TO: David Ploense, Rick Engineering
FROM: Amber Wood Hicken, Planner I
DATE: 4/22/25
SUBJECT: Douglas 234 Dunkin Donuts, Site Plan
Review Comments 04

**SITE PLAN FOR
DUNKIN' DONUTS
DOUGLAS 234, FILING NO. 6,
AMENDMENT 1, LOT 4**

5TH SUBMITTAL

COVER SHEET

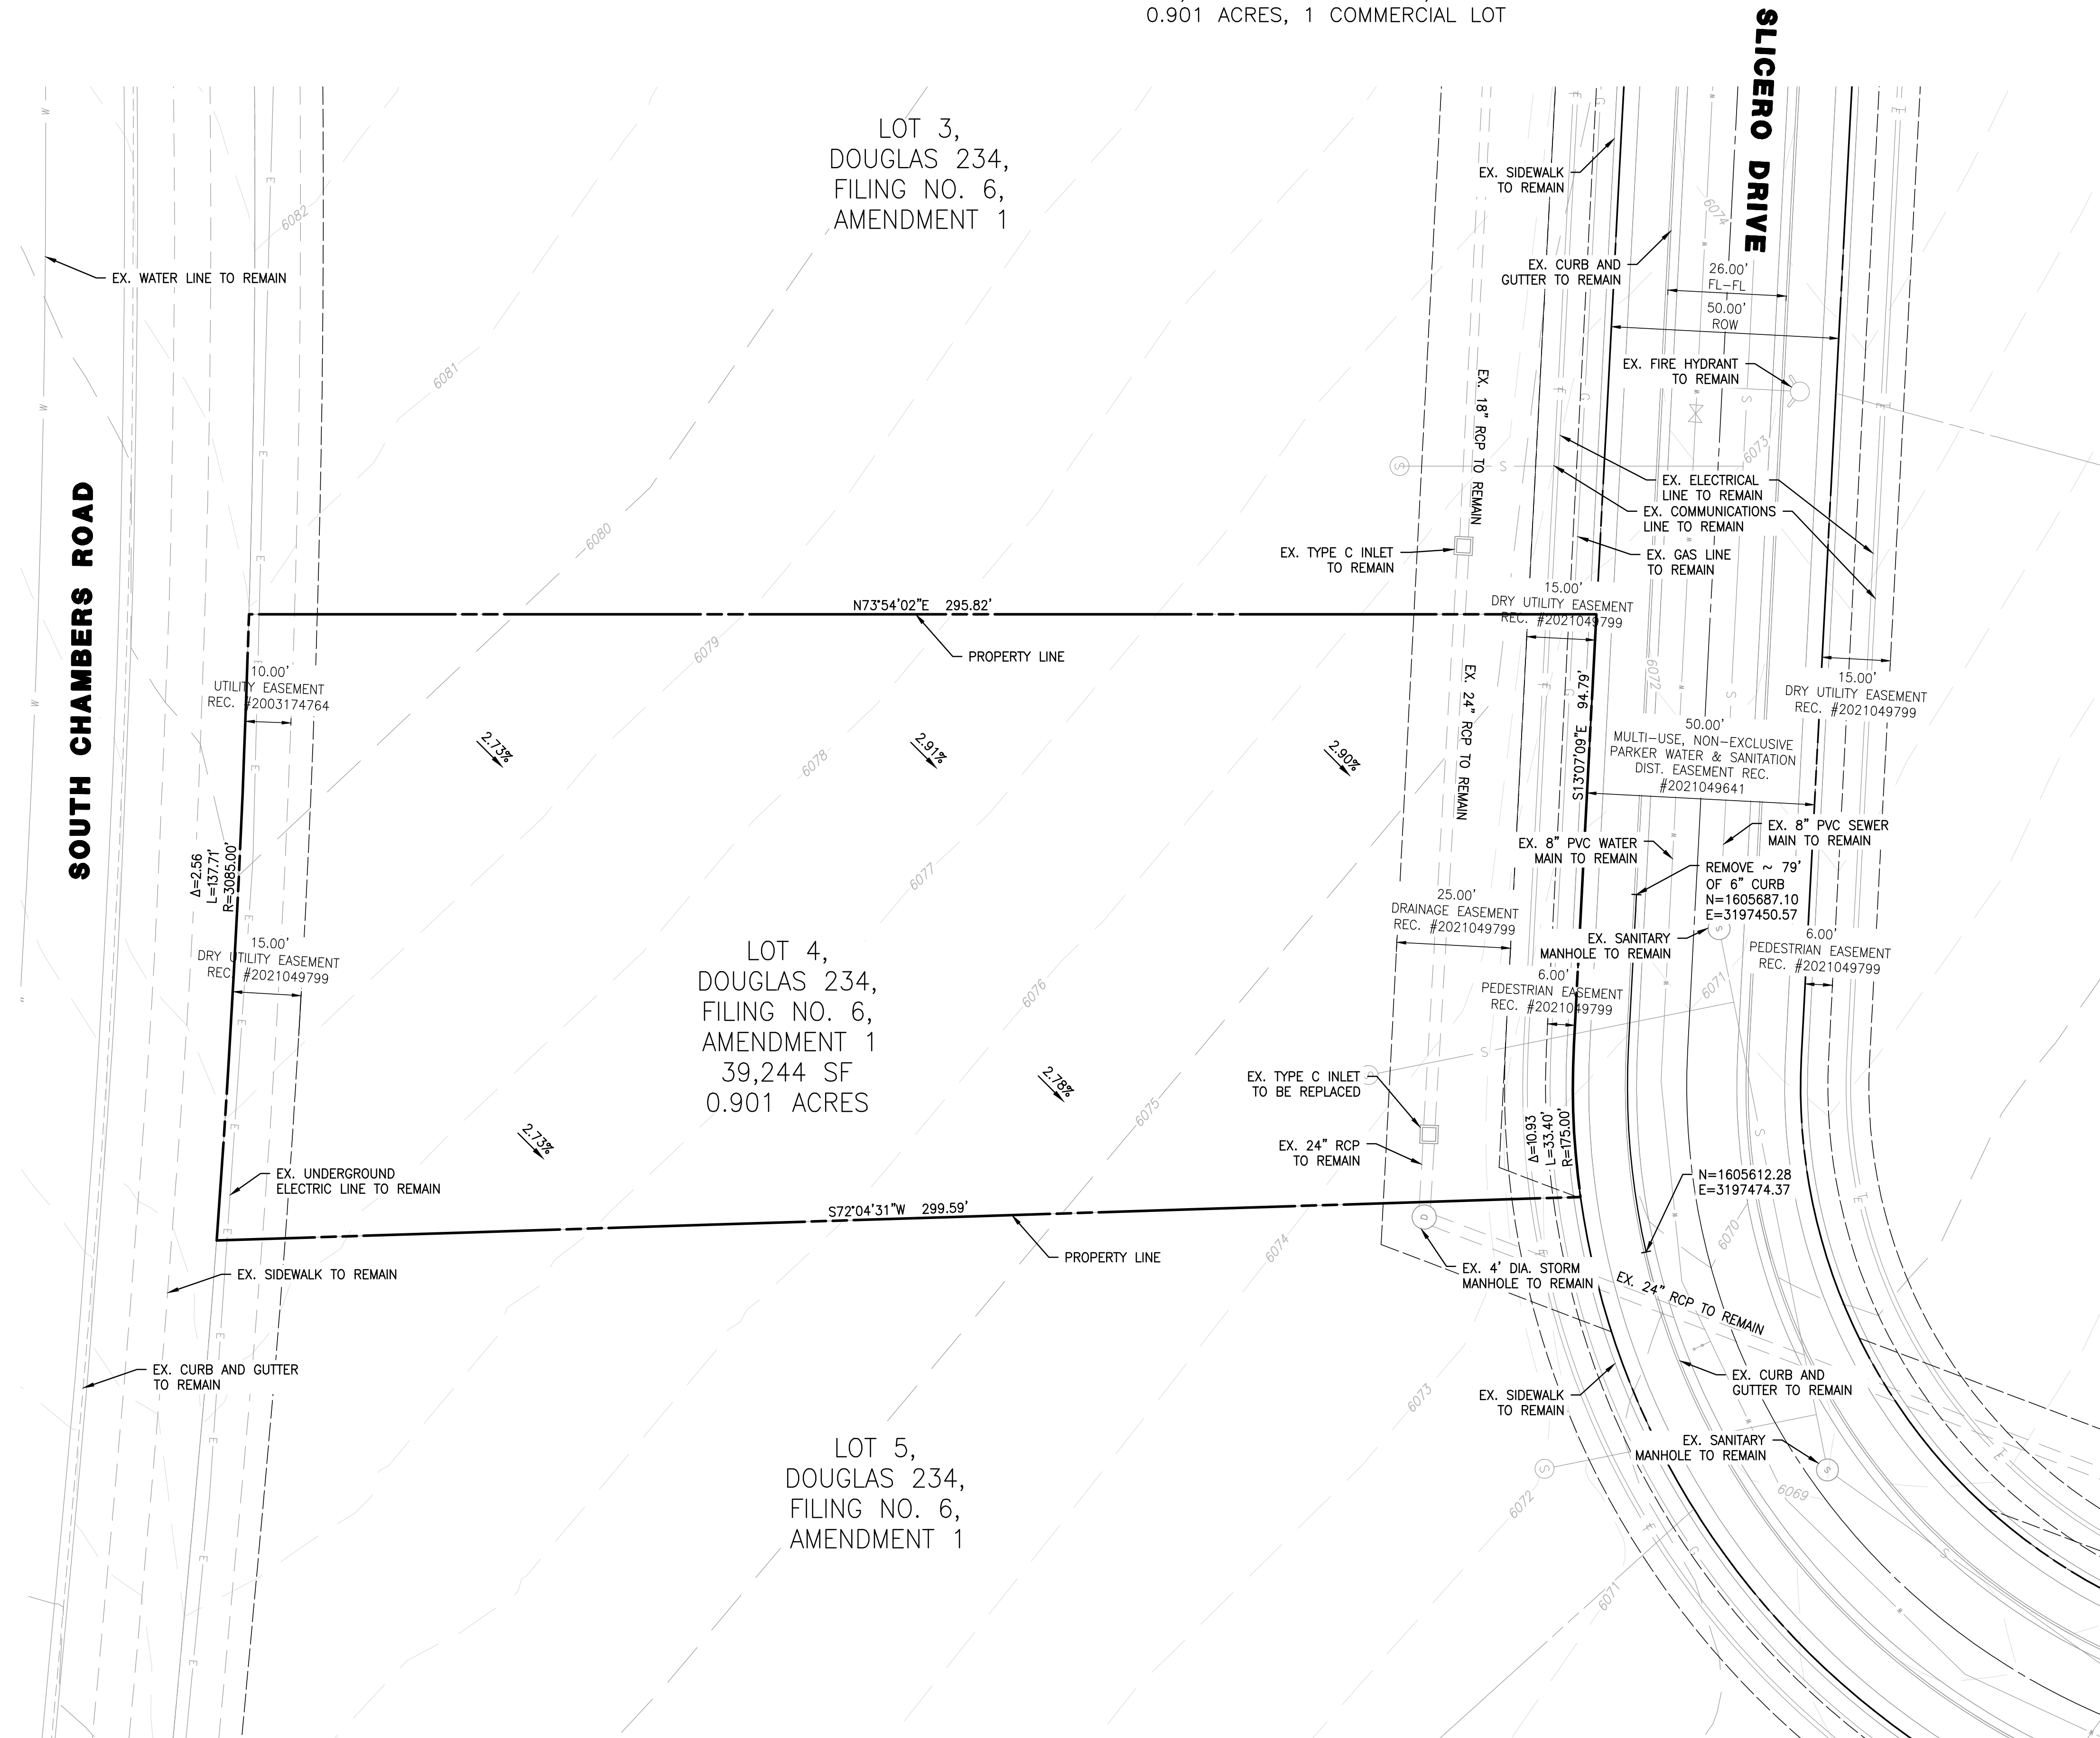
show calculation. 1 per 3 persons design capacity

PRELIMINARY UTILITY PLAN

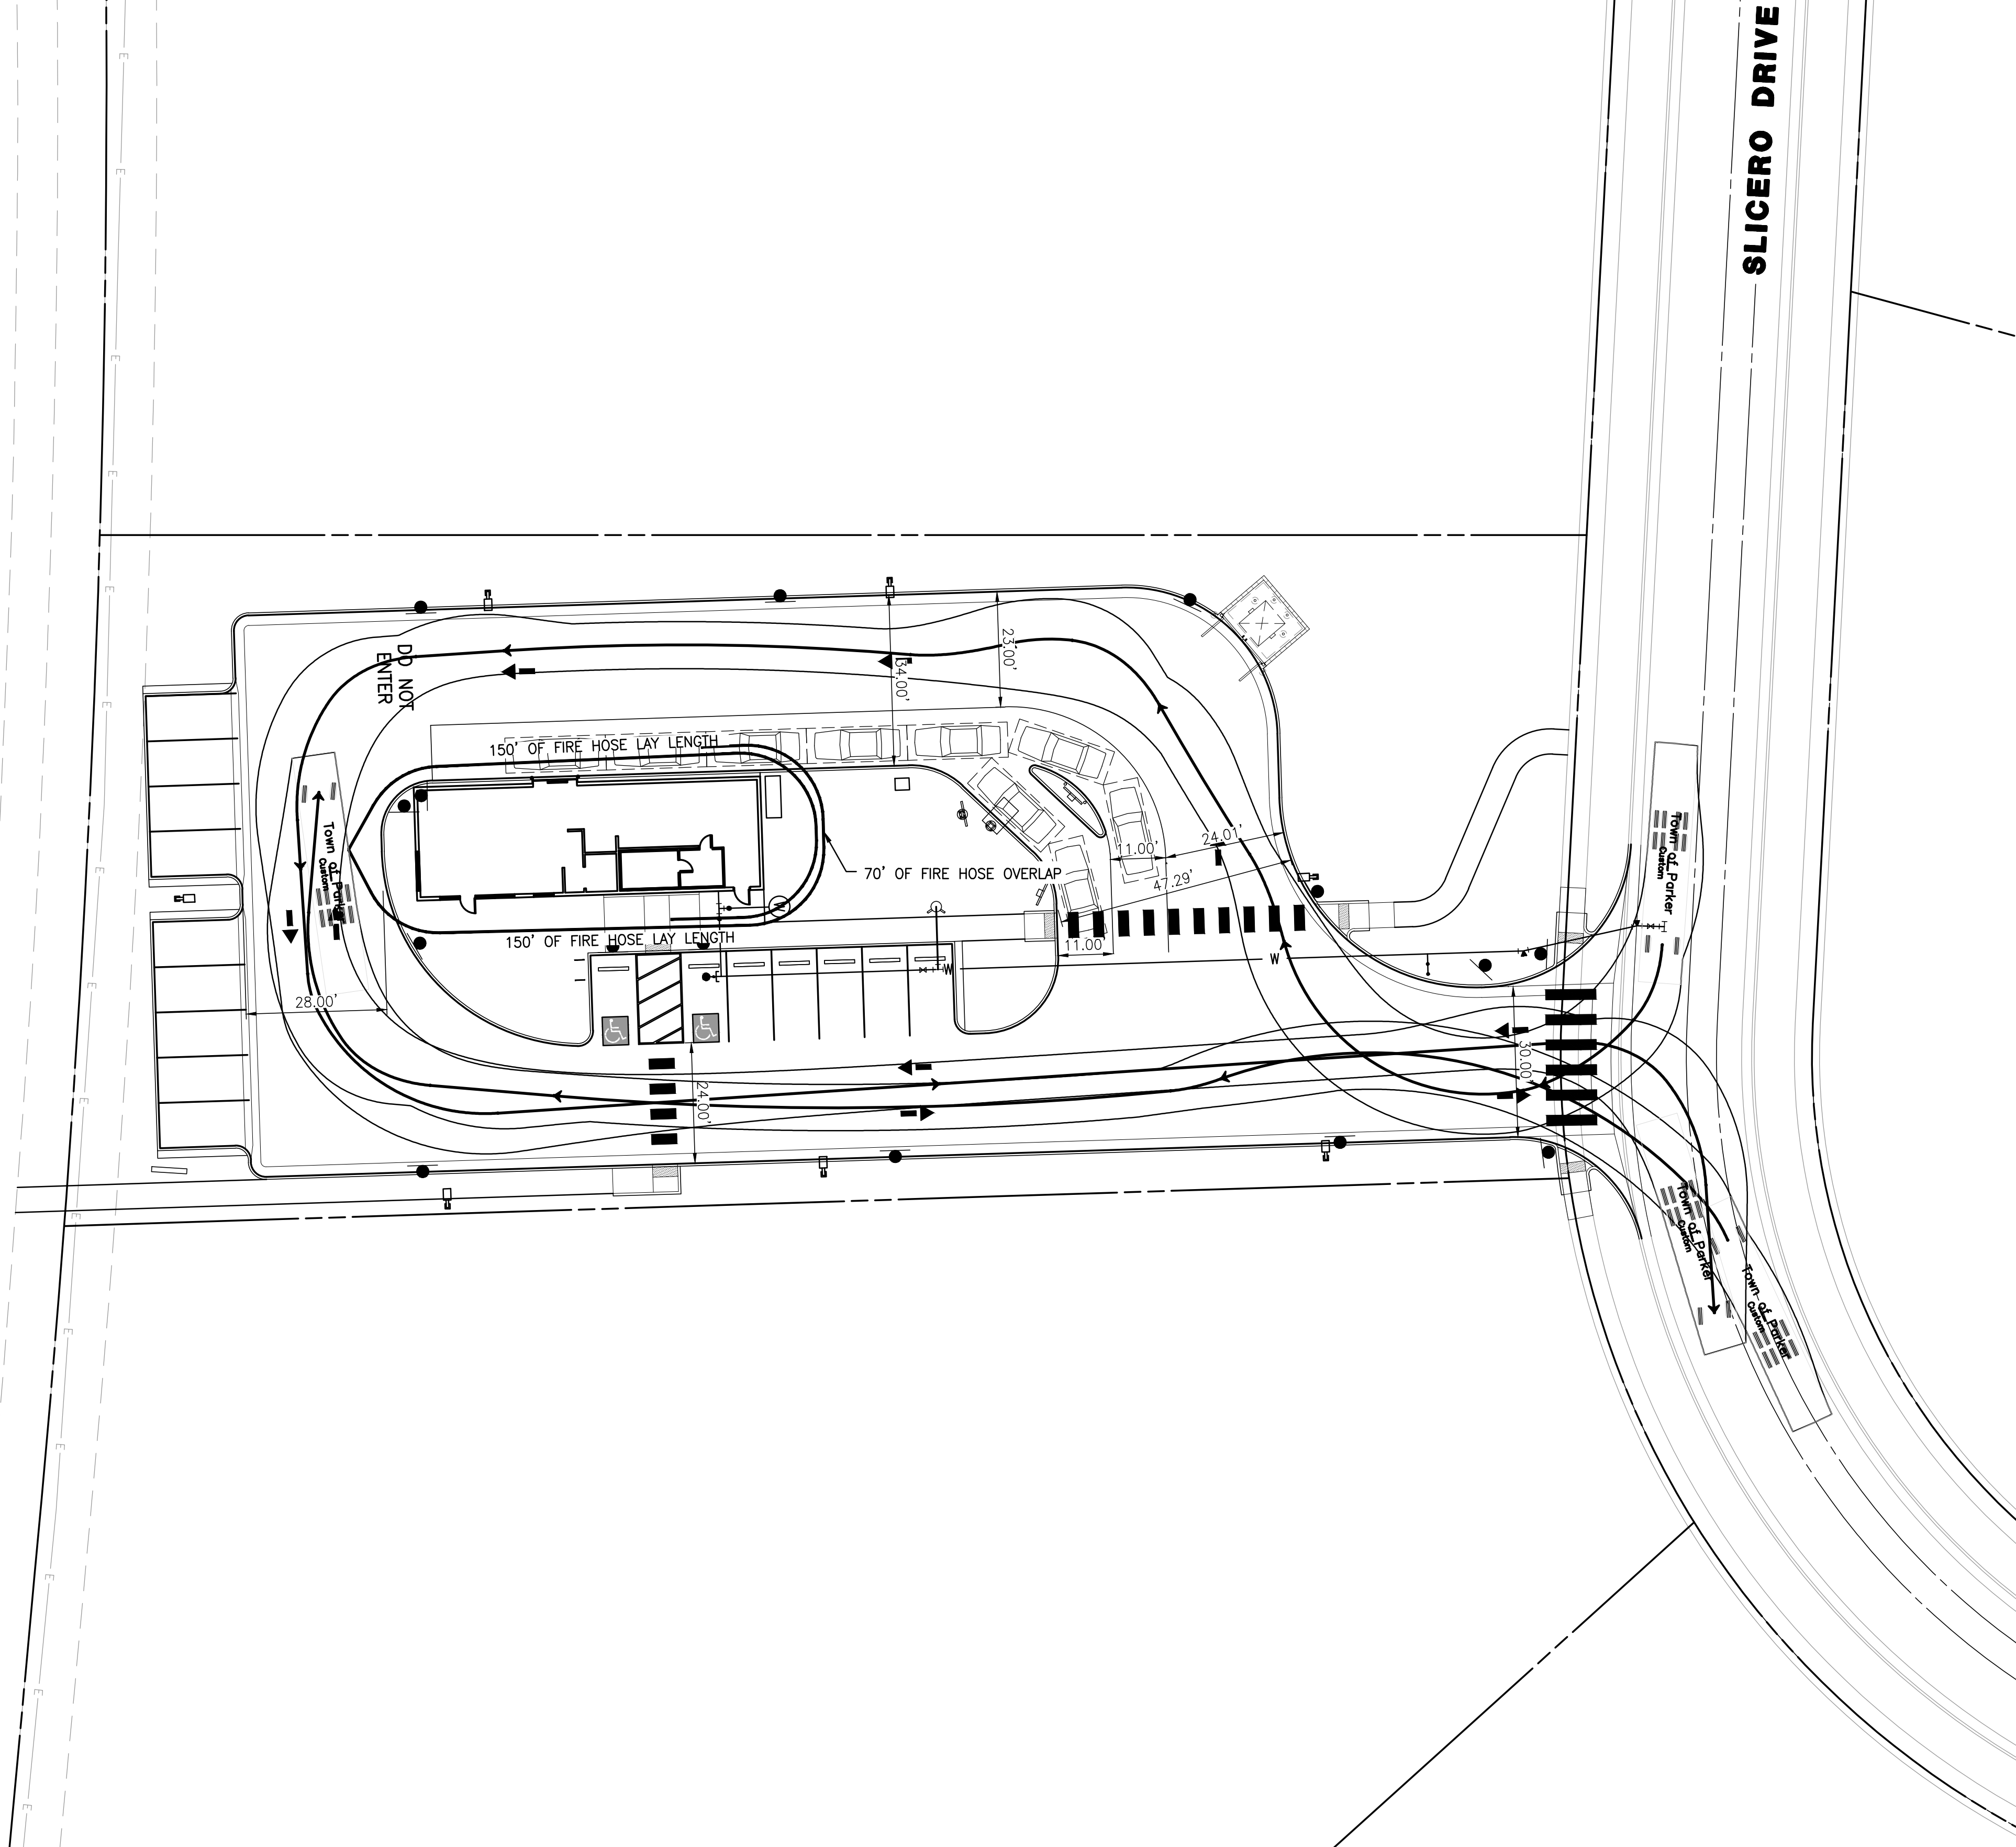
Notes:
The proposed transformer location and shown size do not meet CORE's requirements. Transformer may not open into a drive. The applicant will be required to revise landscape plans to meet CORE requirements.
